TMS320C6203, TMS320C6203B
Digital Signal Processors
Silicon Errata

C6203B Silicon Revisions 2.x, 3.0, 3.1

SPRZ174L
November 2000
Revised February 2004

**Figure 2. Original Transfer**

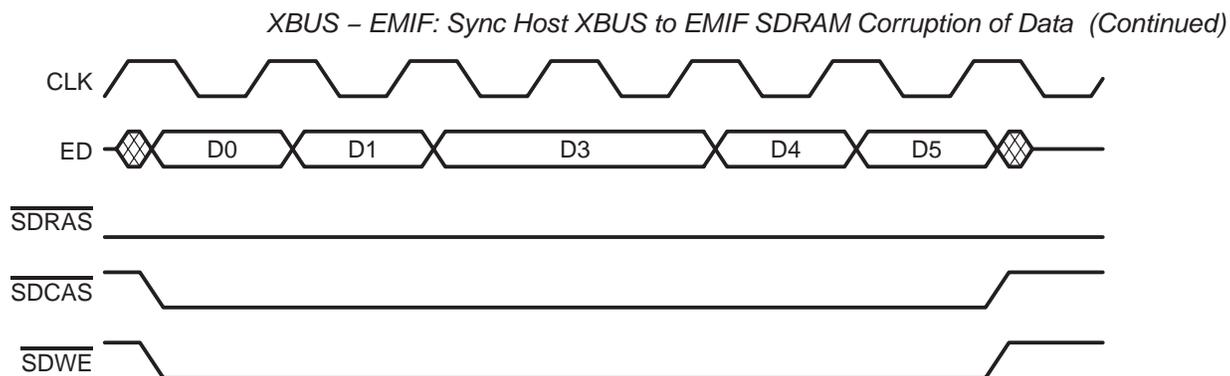
Details: When performing an XBUS Synchronous Host Master Read, corruption of data may occur in some cases where an XBUS wait occurs concurrently with a not-ready input. One word may be overwritten by a subsequent word, corrupting the data. An example of a transfer as it was intended is shown in Figure 2. Figure 3 shows an example of how the data might be corrupted with D3 overwriting D2.

To avoid this issue, use the following:

- Do not stall the XRDY signal during the cycle when there is an XWAIT asserted.
- This frequency may be alleviated by increasing the CPU CLK:CLK frequency ratio past 10:1.

Figure 4. Correct Transfer of Address and Data via the Synchronous Host Port Mode of the Expansion Bus

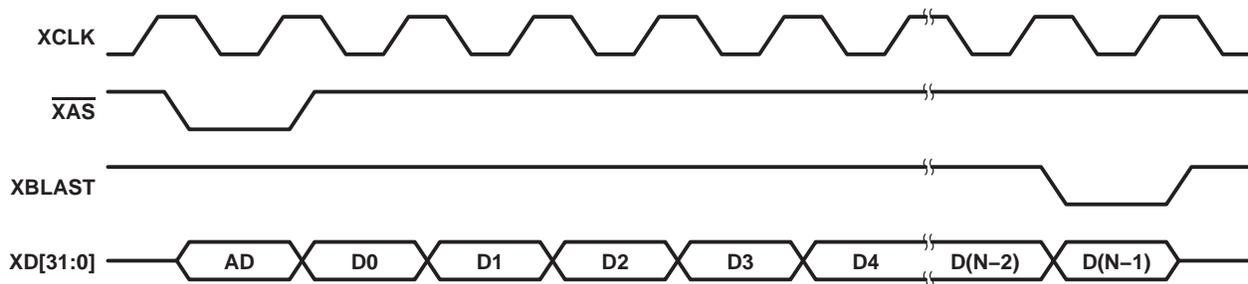
Details: While the expansion bus is operating in Synchronous Host Port Mode, certain expansion Bus output signals may be corrupted. The corruption occurs on output signals only and there are no known issues with any other XBUS modes (Asynchronous Host Mode, Asynchronous I/O Mode, or Synchronous FIFO Mode). In Synchronous Host Port Mode, some or all outputs of the XD signal lines move from the next word into the current word being transferred. This corruption not only affects the XD signal lines, but the output control signals as well (XAS, XBLAST, etc.). Figure 4 shows what a typical Synchronous Host transfer should look like. Figure 5 shows the address (AD), as well as data word 2 (D2) being corrupted by the next word. In this figure, the address is corrupted by D0 and D2 is written over by D3. Figure 6 is an example showing D0 being completely corrupted by D1 and D3 being partially corrupted by D4. The transfer should be 0x0001, 0xFF02, 0x0003, ..., 0xFF1F to Address 0x8000.

The best method of reducing the number of failures resulting from this issue is to increase the voltage and decrease the CPU Clock speed. For Rev. 2.1 and earlier revisions, 1.5-V / 300-MHz devices should operate correctly at 1.7 V / 250 MHz. This issue will be fixed in the next major revision.

Figure 7. FIFO Read Timing, Glueless Read Mode

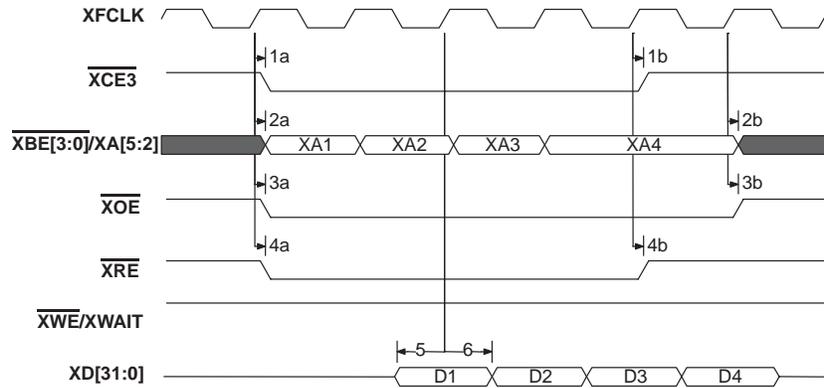
- \overline{XCE} high-to-low transition after XFCLK high (Parameter 1a in Figure 7 and Figure 8)
- $\overline{XBE}/XA[5:2]$ valid after XFCLK high (Parameter 2a in Figure 7 and Figure 8)
- \overline{XOE} high-to-low transition after XFCLK high (Parameter 3a in Figure 7 and Figure 8)
- \overline{XRE} high-to-low transition after XFCLK high (Parameter 4a in Figure 7 and Figure 8)

- \overline{XCE} low-to-high transition after XFCLK high (Parameter 1b in Figure 7 and Figure 8)
- $\overline{XBE}/XA[5:2]$ invalid after XFCLK high (Parameter 2b in Figure 7 and Figure 8)
- \overline{XOE} low-to-high transition after XFCLK high (Parameter 3b in Figure 7 and Figure 8)
- \overline{XRE} low-to-high transition after XFCLK high (Parameter 4b in Figure 7 and Figure 8)

Workaround: Do not use the glueless synchronous FIFO interface. Use external glue logic to meet the FIFO hold time requirements.

Figure 9. FIFO Write Timing

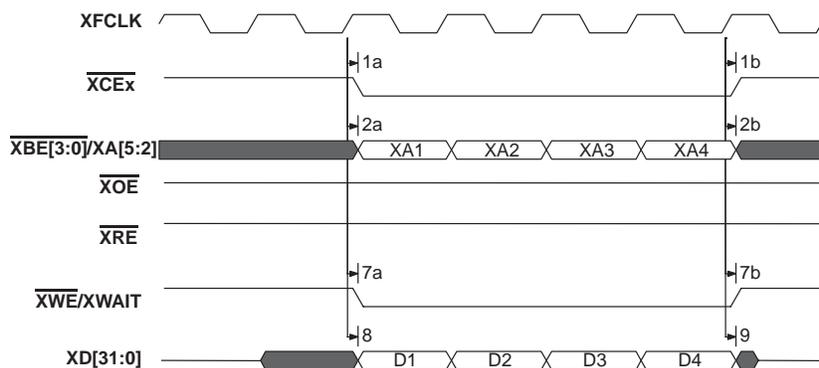
- \overline{XCE} high-to-low transition after XFCLK high (Parameter 1a in Figure 9)
- \overline{XCE} low-to-high transition after XFCLK high (Parameter 1b in Figure 9)
- $\overline{XBE}/XA[5:2]$ valid after XFCLK high (Parameter 2a in Figure 9)
- $\overline{XBE}/XA[5:2]$ invalid after XFCLK high (Parameter 2b in Figure 9)
- \overline{XWE} high-to-low transition after XFCLK high (Parameter 7a in Figure 9)
- \overline{XWE} low-to-high transition after XFCLK high (Parameter 7b in Figure 9)
- XD[31:0] valid after XFCLK high (Parameter 8 in Figure 9)
- XD[31:0] invalid after XFCLK high (Parameter 9 in Figure 9)

In glueless FIFO interfaces, this zero delay time may violate the hold time of the FIFO.
(Internal reference number C631252)
